HORSHAM DISTRICT COUNCIL CONSULTATION

TO:	Horsham District Council – Planning Dept
LOCATION:	New Place Nurseries London Road Pulborough West Sussex
DESCRIPTION:	Reserved Matters application pursuant to Outline Planning Consent DC/21/2321, as varied by application DC/24/1204. The Reserved Matters comprise details of 160 no dwellings, associated internal access roads, parking and landscaping for areas east of the right of way. Details of appearance, landscaping, layout and scale to be considered.
REFERENCE:	DC/24/1676
RECOMMENDATION:	Objection / More Information / Modification

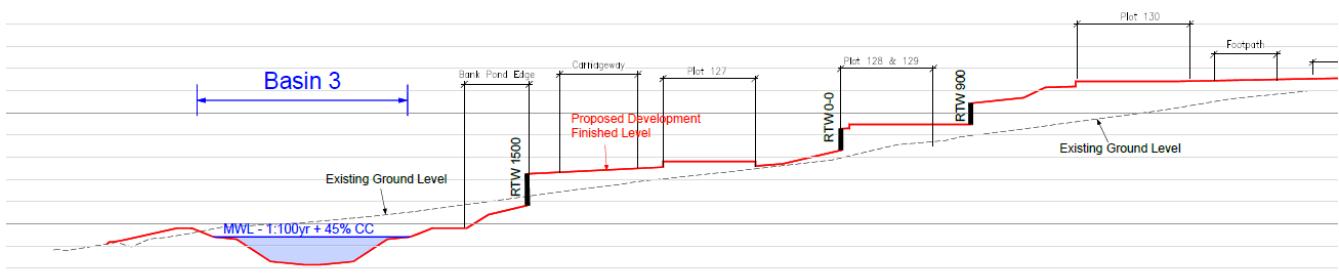
1. Significant changes have been made to the framework plan and concern is raised with the effect this has on the existing landscape features; but also the landscape concept design and key features, such as the landscape framework and the viewing corridor through the site, which is now significantly diluted.
2. The planted corridor (noted as 2, within the illustrative layout under DC/24/1676), has been removed and the proposed dwellings moved hard against the footpath/road. The original concept had been introduced to mitigate some of the development effects. The wider landscape buffer within this alignment was proposed to filter views and soften the

appearance of the development in the elevated position. As such, this must be reinstated as it's an important mitigation measure and considered as part of the acceptability of the scheme.

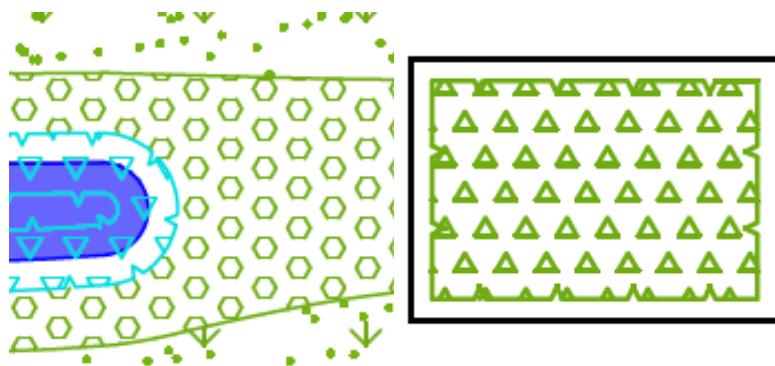
7. The levels plan does not appear to reflect contours or retaining walls fully. For example, clarification is requested for the area highlighted in yellow, below. Is a retaining wall also needed near the footpath?

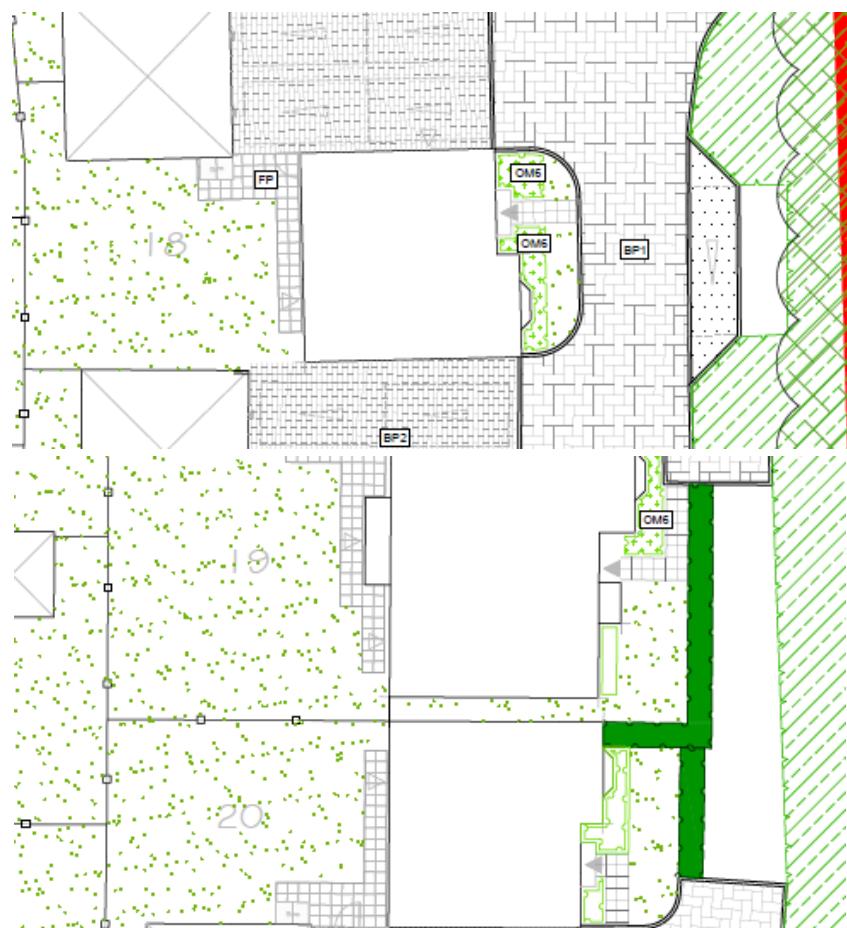
13. Clarification is requested in regard to the hexagonal hatch [below, left] which does not appear in the legend, and if it is meant to indicate reedbed [below, right].

14. Clarification is requested in regard to the green diagonal hatch [below] which does not appear in the legend. It appears that these areas illustrate retained groups of trees and vegetation, however Arboricultural plans indicate their removal.

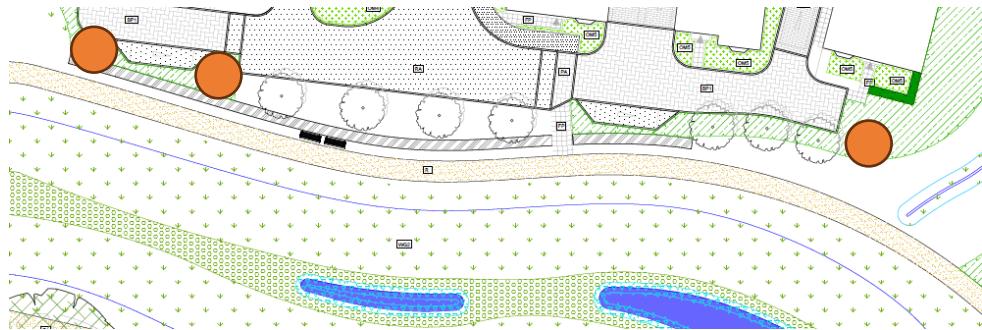
19. As per our previous comments under PE/24/0081, parking bays must be broken down into smaller sections and include meaningful planting to soften courts. Please provide further tree planting, particularly on the eastern and northern stretches of the bays below.

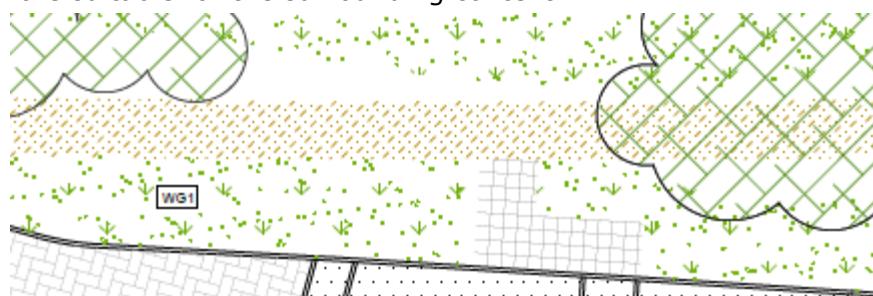
20. As per our previous comments, we request the provision of trees in between the attenuation basin and dwellings on the southern boundary of the central dwelling parcel. Please see our suggestions indicated in orange, below.

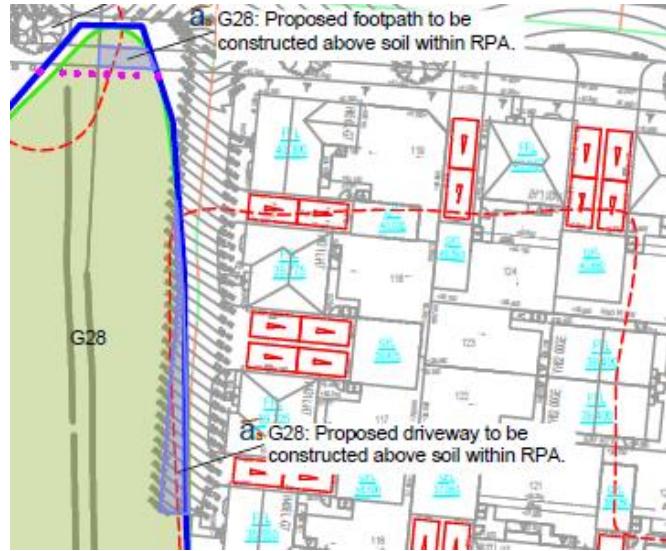
22. We recommend amending the flag paving in this location [below] to be informal path, which is more suitable for the surrounding context.

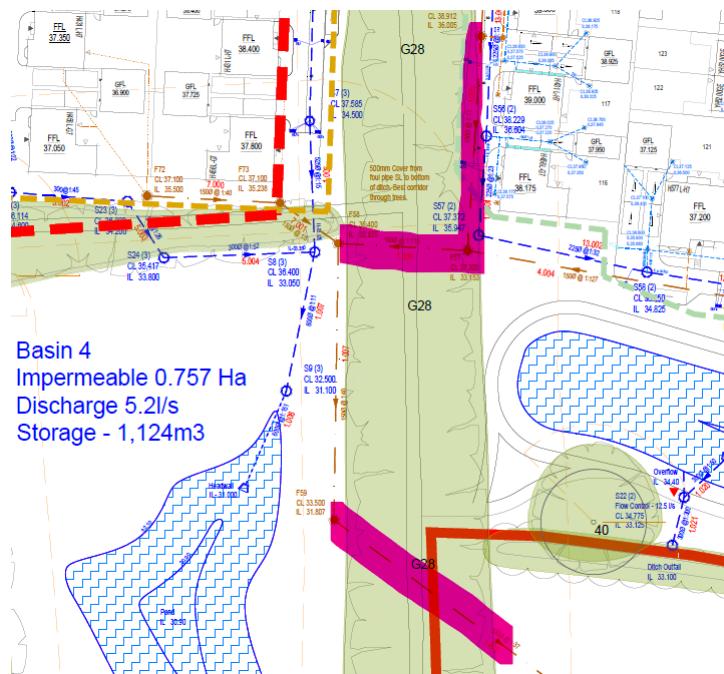
23. We request that the road layout is adjusted to avoid the RPA of Category A G28, which is classified as a 'high value collection of trees'. Given the undeveloped nature of the site, and approved parameter plan, it is required that RPAs are avoided in order to retain and protect existing trees and hedgerows, as per aims set out within the Design and Access Statement, as well as policy 33 of the HDPF.

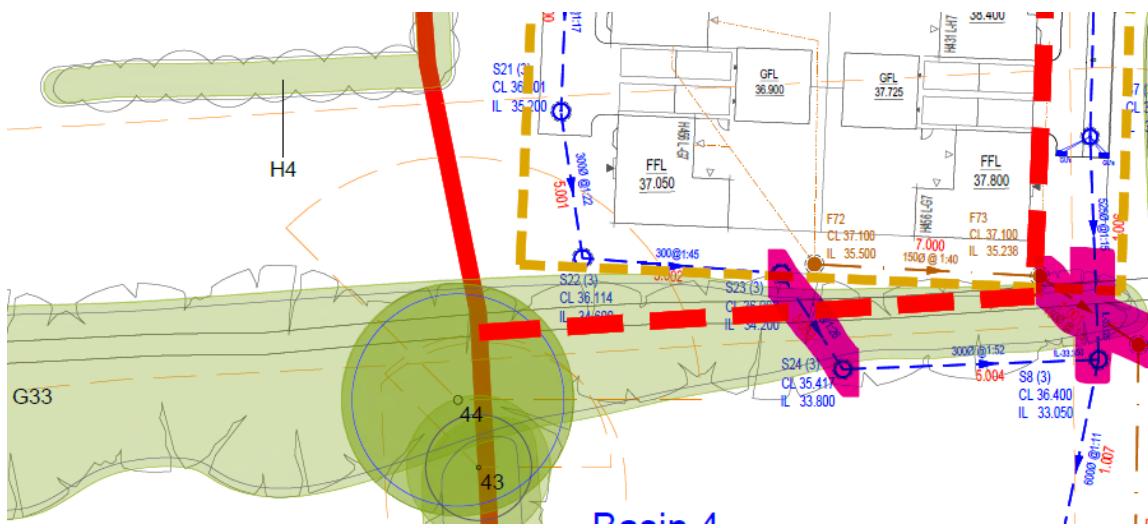
- i. Of key concern is aforementioned Category A G28, where multiple drainage paths are proposed [highlighted in pink, below]. We recommend that drainage avoids the RPAs of G28 entirely and that other routes are explored. If it can be demonstrated that there is no alternative option but to encroach G28, only one drainage trench should be proposed at minimum and advice from the HDC Arboriculturist should be sought in order to minimise adverse effects.

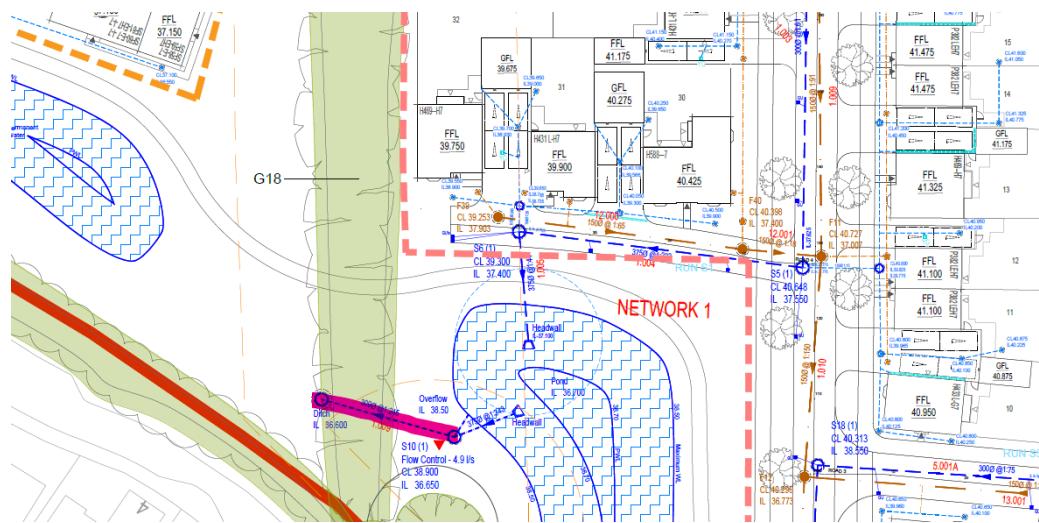
- j. As above, multiple drainage routes pass through G33 [highlighted in pink, below]. While this group of trees is of lesser quality than G28, it still positively contributes to the character of the area, therefore should be retained and safeguarded. Please modify proposals to avoid and minimise disturbance to the rooting medium.
